Interactive comment on “Performance assessment of a triple-frequency spaceborne cloud–precipitation radar concept using a global cloud-resolving model” by J. Leinonen et al.

We thank reviewer #1 for the helpful and extensive comments. Our point-by-point responses can be found below each comment in italics.

Fig. 1. A conceptual example of nonuniform beam filling leading to a larger number of detected points.

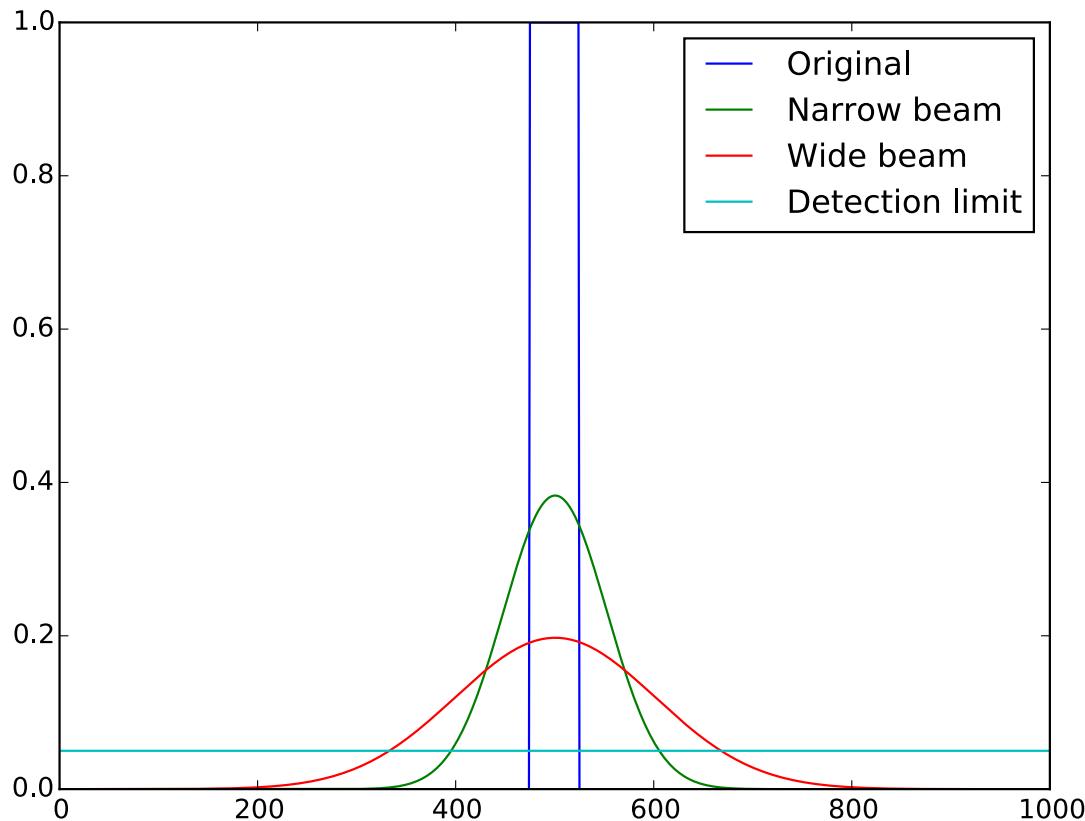
6) Line 22-24 Page 4159 : I can't understand how this is possible.

A conceptual drawing of this effect is given in the attached plot. There, it can be seen that the wider beam results in the signal being detected over a larger area. In the case discussed in Sect. 5.2, the magnitude of this effect is larger than the area-decreasing effect of the loss of sensitivity. More detail was added to the sentence in order make it clearer to the reader why this effect arises.
